BRUNSWICK STEAM ELECTRIC PLANT, UNIT NO. 2  
DOCKET NO. 50-324/LICENSE NO. DPR-62  
TRANSMITTAL OF REVISIONS TO THE CORE OPERATING LIMITS REPORT AND  
SUPPLEMENTAL RELOAD LICENSING REPORT

The purpose of this letter is to submit Revision 1 of the Cycle 14 Core Operating Limits Report (COLR) and Revision 1 of the Cycle 14 Supplemental Reload Licensing Report (SRLR) for the Brunswick Steam Electric Plant (BSEP), Unit No. 2. BSEP, Unit 2 Technical Specification 5.6.5.d requires that any midcycle revisions of the COLR be provided to the NRC.

**BRUNSWICK UNIT 2, CYCLE 14**  
**CORE OPERATING LIMITS REPORT**

**Supplemental Reload Licensing Report**

Power-Dependent MAPLHGR Limit, MAPLHGR (P)

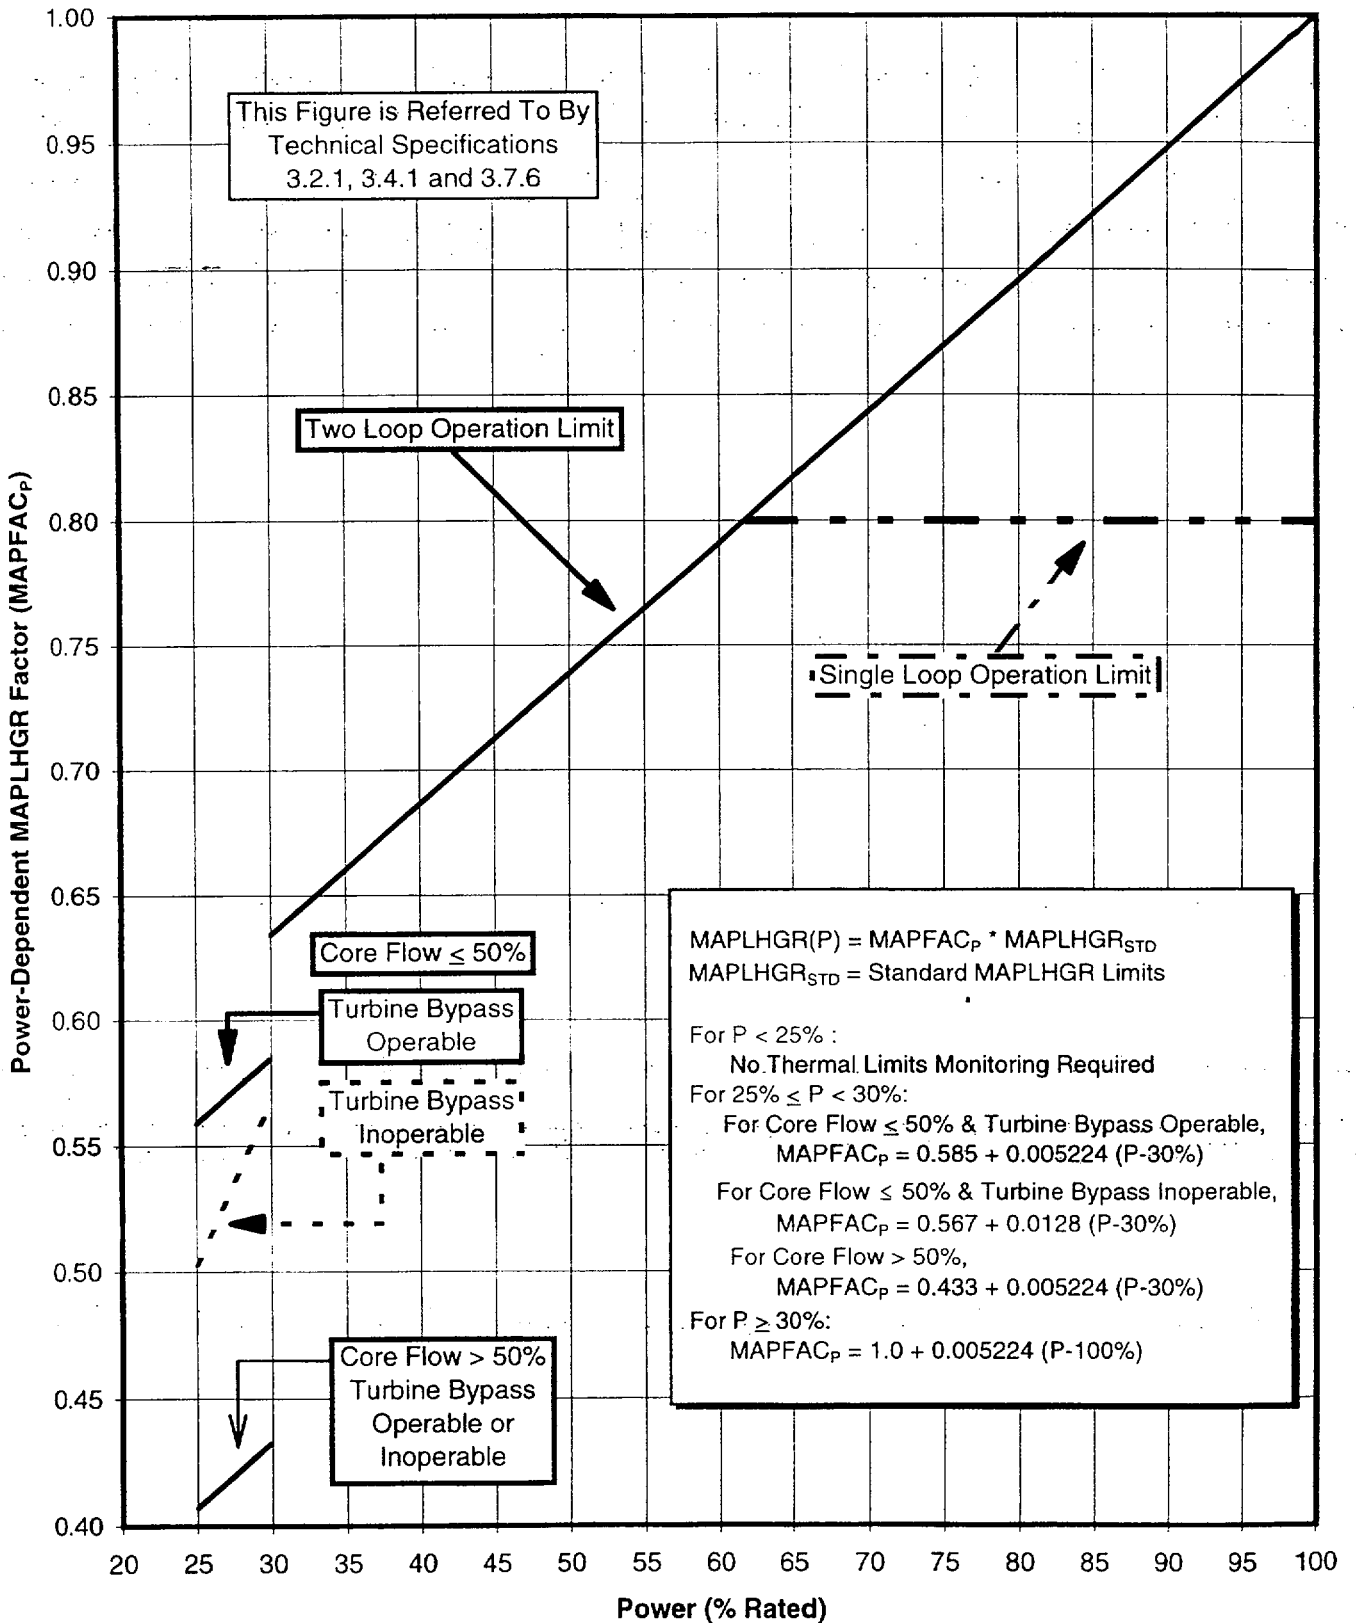
LCO 3.2.1, Average Planar Linear Heat Generation Rate (APLHGR) Limits: in accordance with Reference 1 as shown in Figure 10, TBPOOS requires a reduction in the MAPLHGR(P) limits between 25% and 30% power.

Power - Dependent MCPR Limit, MCPR (P)

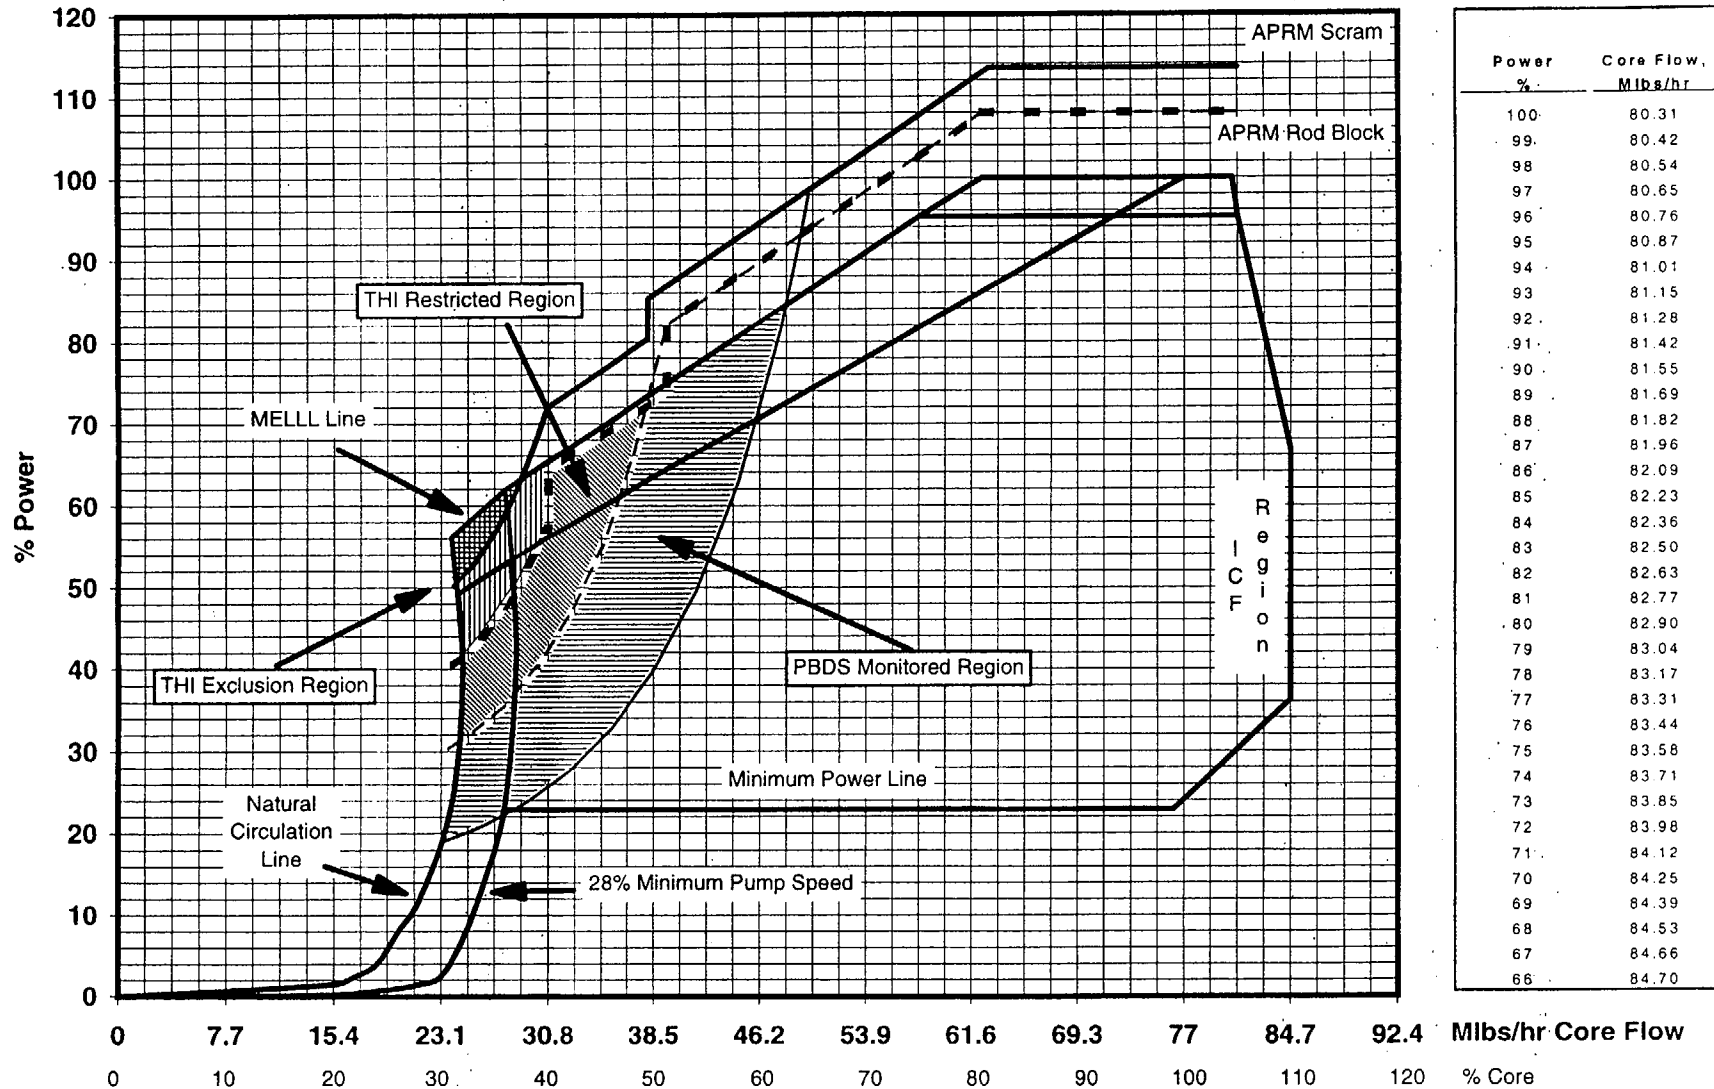
LCO 3.2.2, Minimum Critical Power Ratio (MCPR) Limits: in accordance with Reference 1, TBPOOS requires an increase in the MCPR(P) multiplier between 25% and 30% power, as shown in Figure 12. TBPOOS also requires increased MCPR limits, included in Table 1.
